TECHNICAL BULLETIN

NO. 200-008

SUBJECT : Rework of Canopy Rail Lock Hole

AIRCRAFT AFFECTED : All FA-200 series aircraft

Figure 1

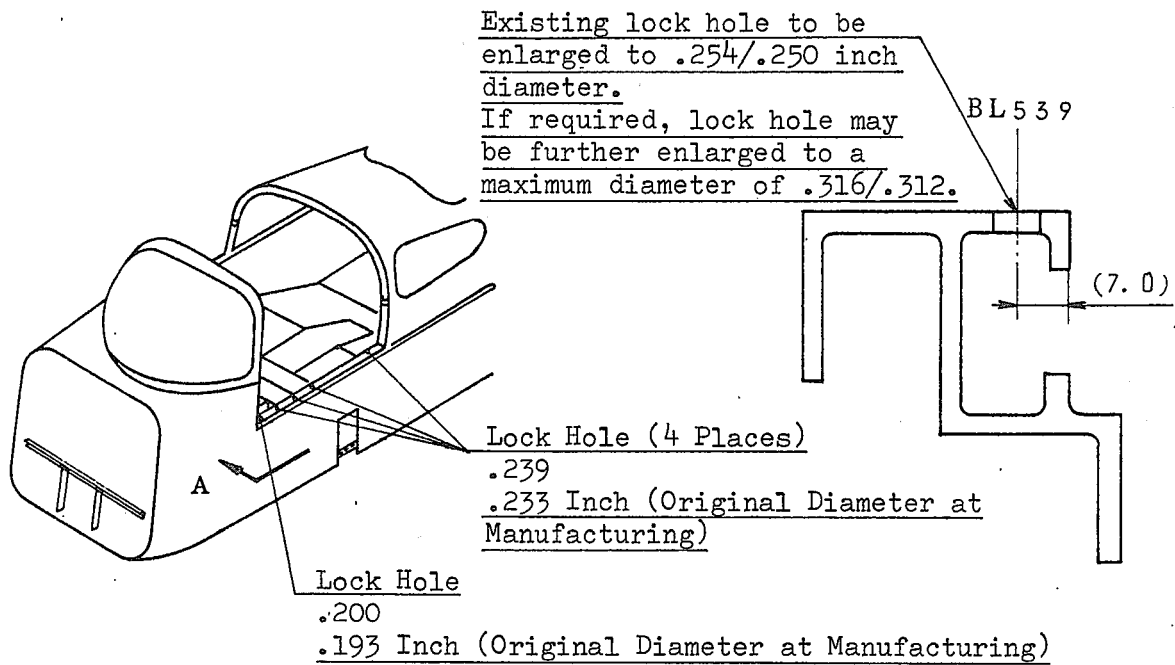
- (1) Remove canopy in accordance with FA-200 service manual, para 7-4-1
- (2) Enlarge existing ten (10) lock holes (5 places each side) to .254/.250 inch diameter.
- (3) The above .254/.250 inch diameter holes may be further enlarged to a maximum diameter of .316/.312 inch, if required to obtain a proper diameter hole.

Figure 2 View A

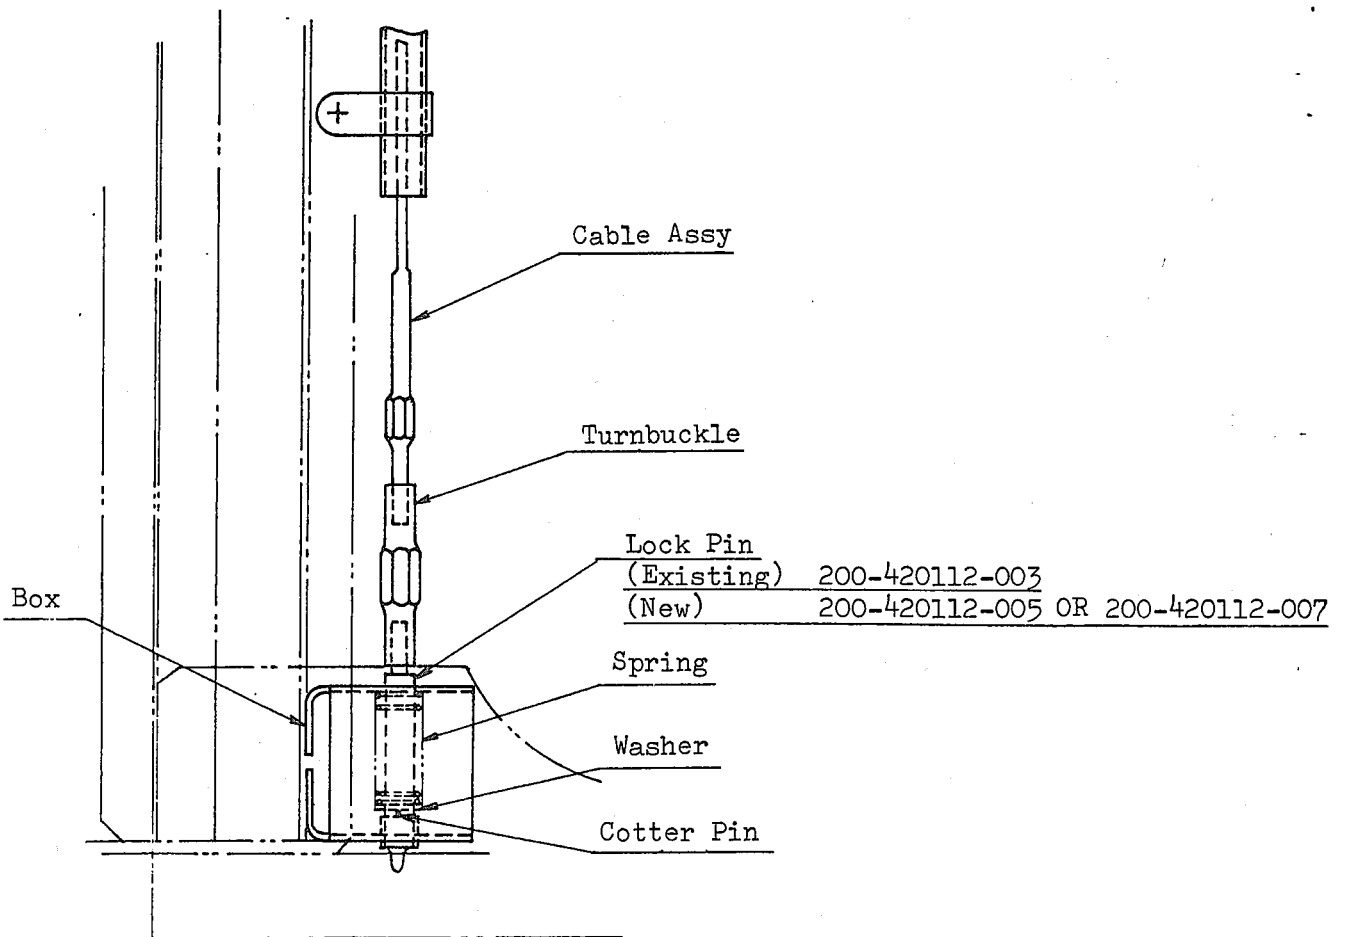
- (1) Remove fwd canopy covers P/N 200-534105-007 and -008
- (2) Remove lock pin as follows : (Reference Figure 2)
 - a. Compress spring and remove cotter pin.

- b. Remove safety wire from turnbuckle, and remove lock pin from turnbuckle. (Pull out lock pin downward)
 - c. If lock pin hole is enlarged to .254/.250 inch diameter, install new lock pin P/N 200-420112-005 in place with spring and washer. If lock pin hole is enlarged to .316/.312, enlarge hole in rail to the same diameter, and install lock pin P/N 200-420112-007 with spring and washer.
 - d. Connect lock pin and cable assy with turnbuckle.
 - e. Install cotter pin.
- (3) Install canopy in accordance with FA-200 service manual, para 7-4-1.
 - (4) Adjust turnbuckle so that canopy lock pins may be properly engaged into holes in canopy rails.
 - (5) After adjustment, secure turnbuckles with safety wire.
 - (6) Install fwd canopy covers P/N 200-534105-007 and -008.
3. Parts Required :
